SUBJECT: PLANS AND PROPOSAL ADDENDUMS

PROJECT: BR 2022(646)

CONTROL: 2121-05-046

**IH 10 UNDERPASS  
AT FM 3380**

# Estimate & Quantity Sheet

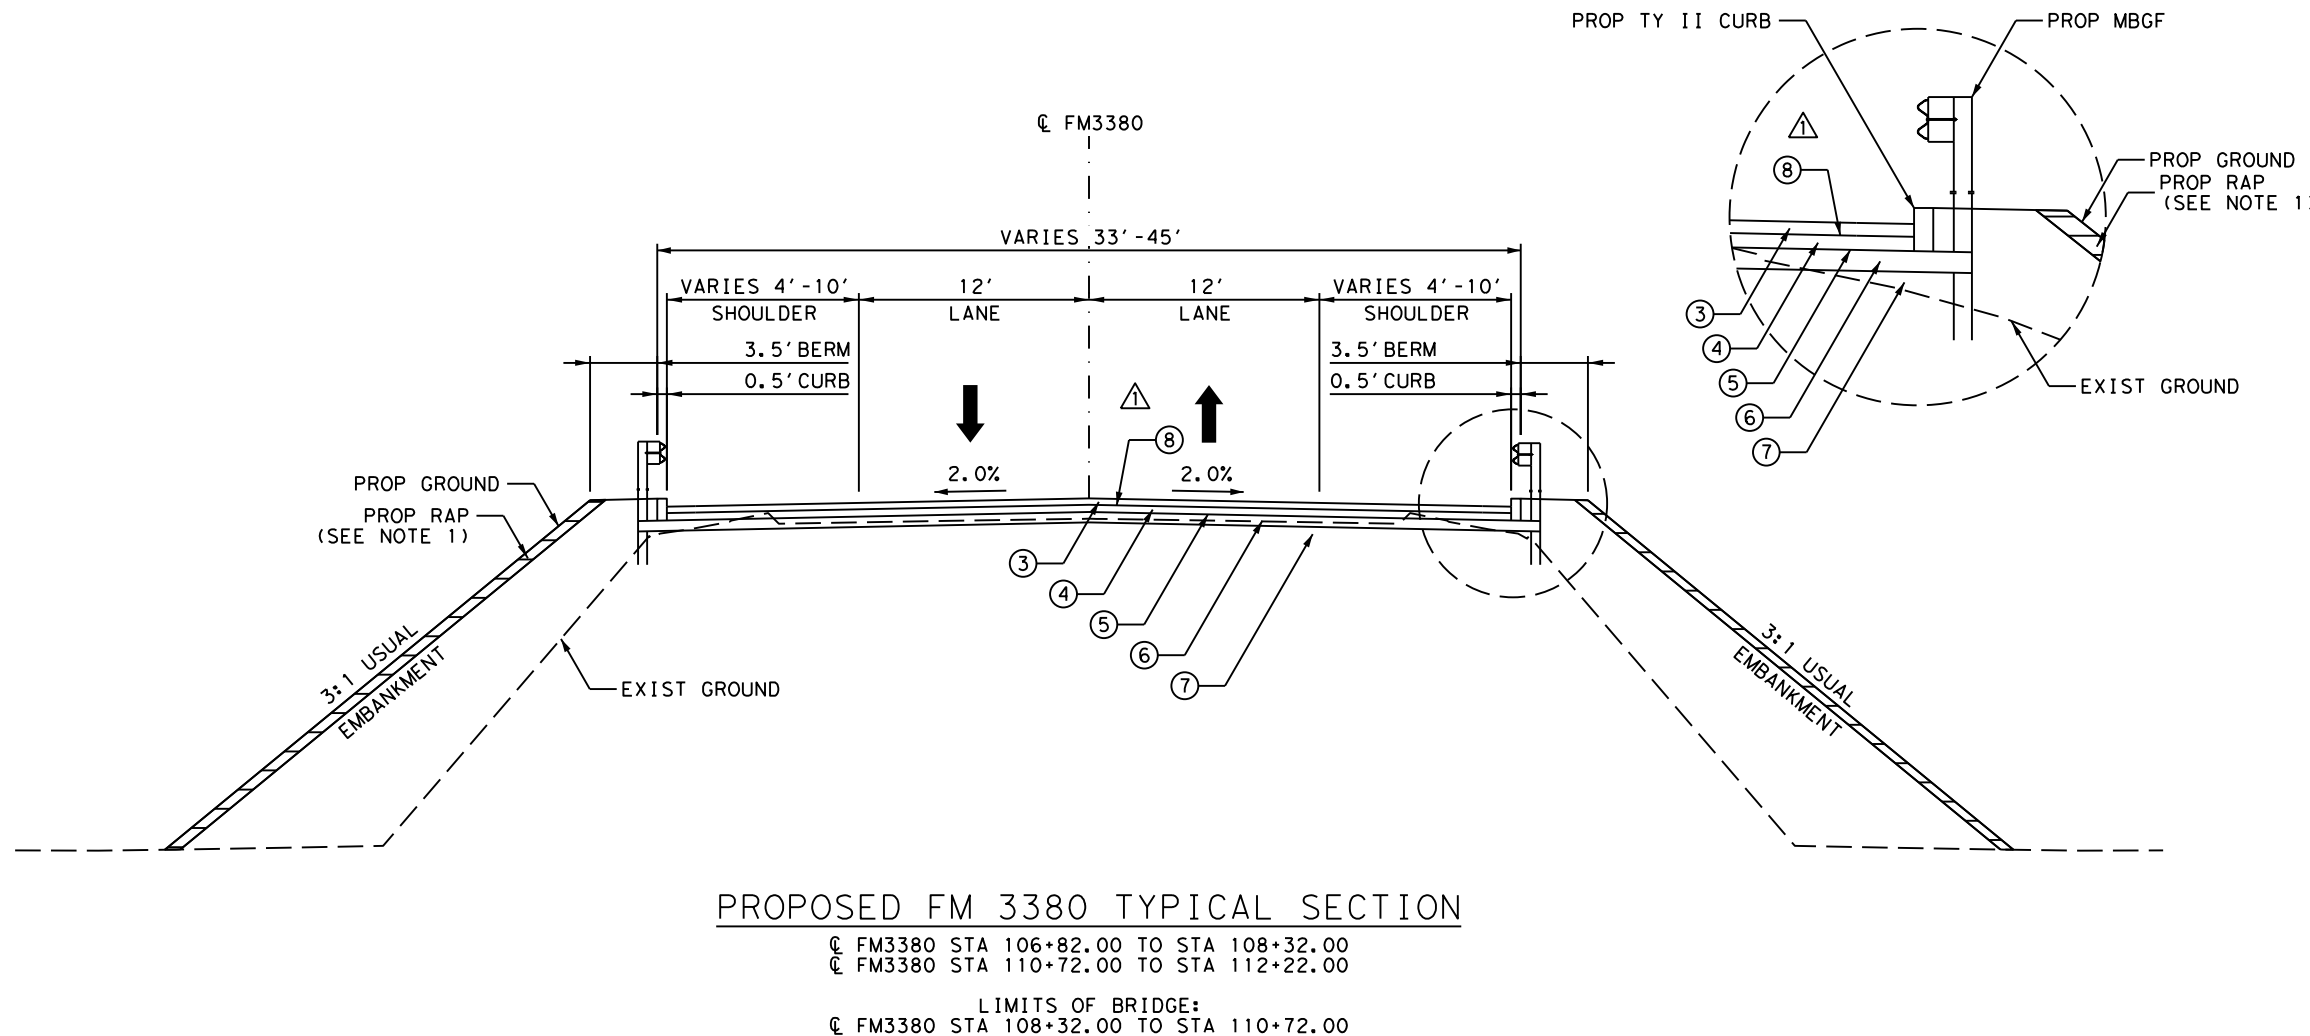
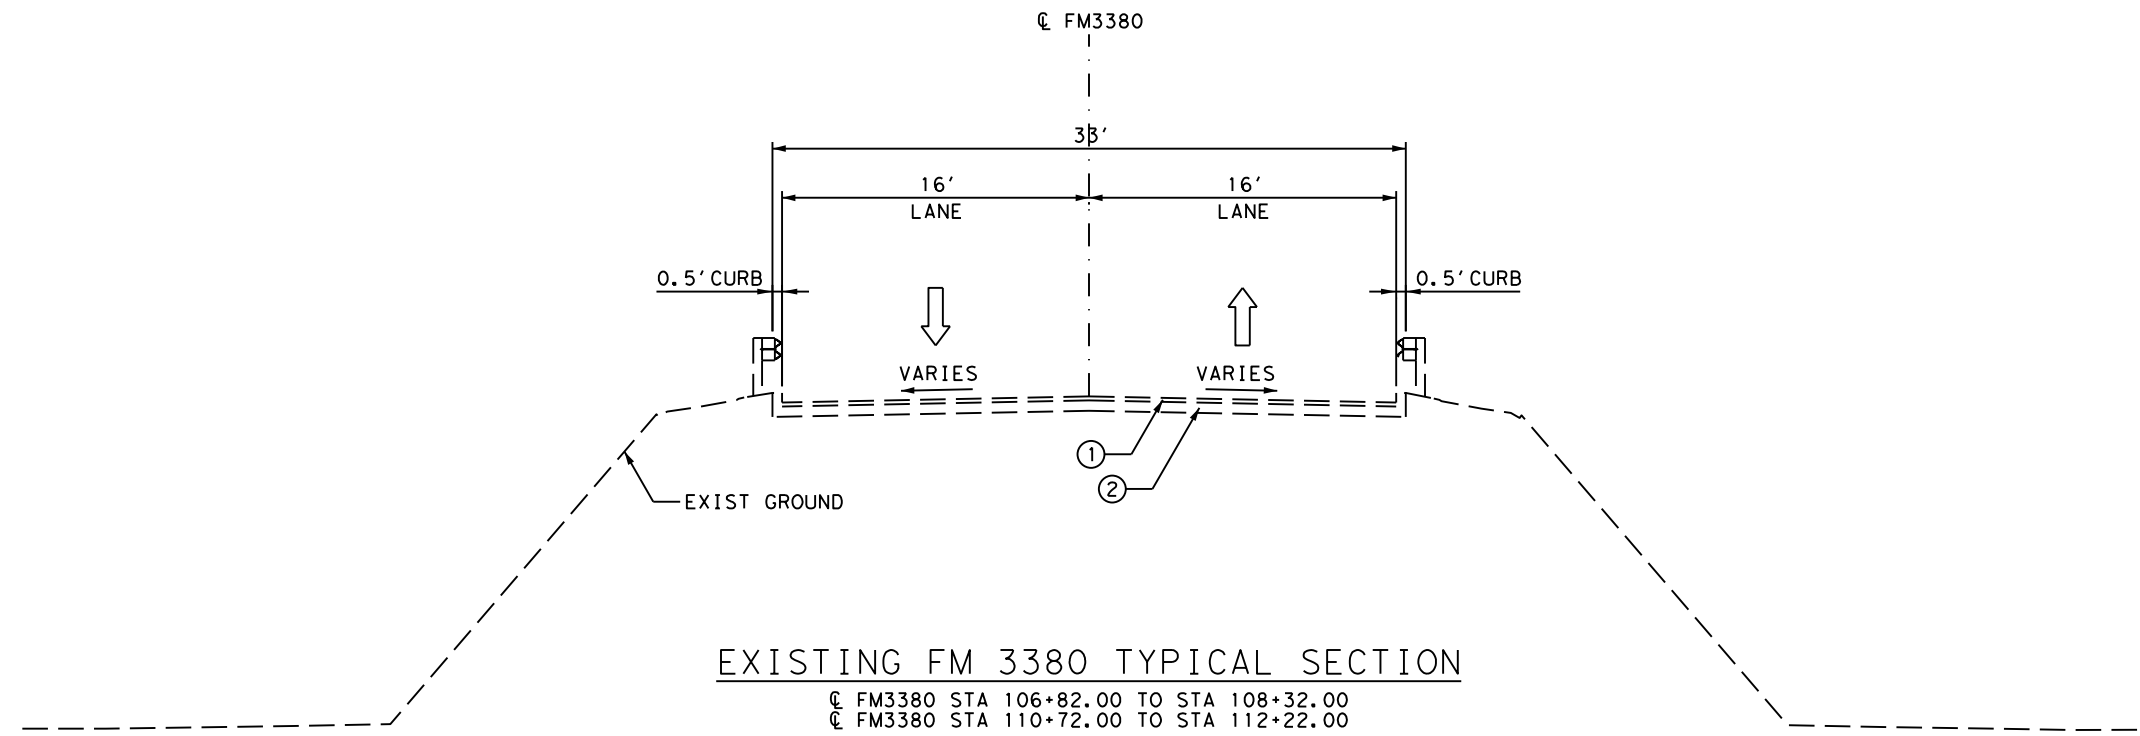
SHEETS 005 AND 005A (E&Q SHEETS): REVISED ITEMS AS NOTED IN THE BID INSERTS ABOVE.

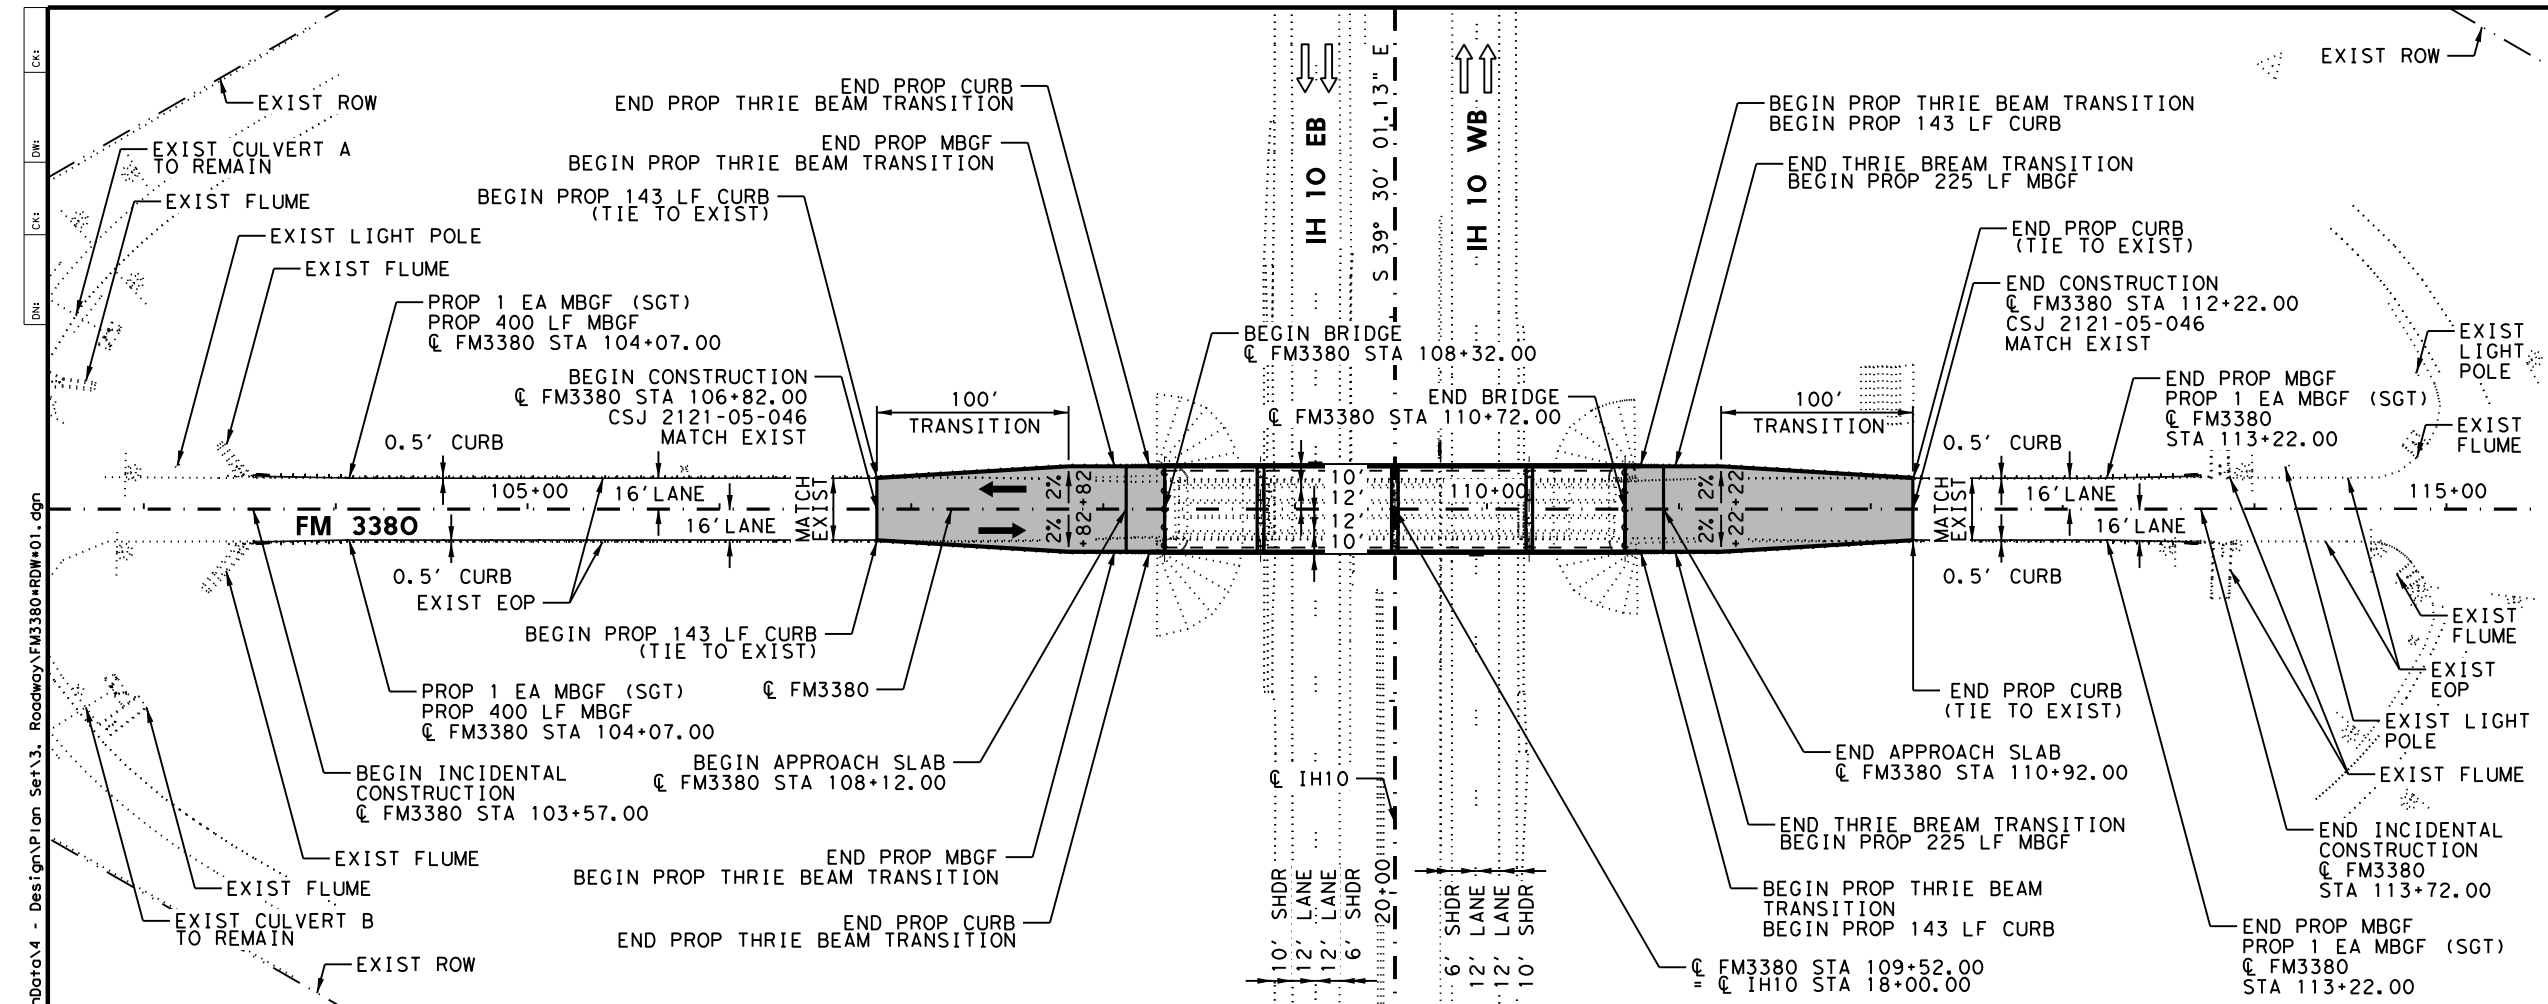
SHEET 010A (EPIC): REVISION TO REQUIRED ACTION ON ASBESTOS NOTES.
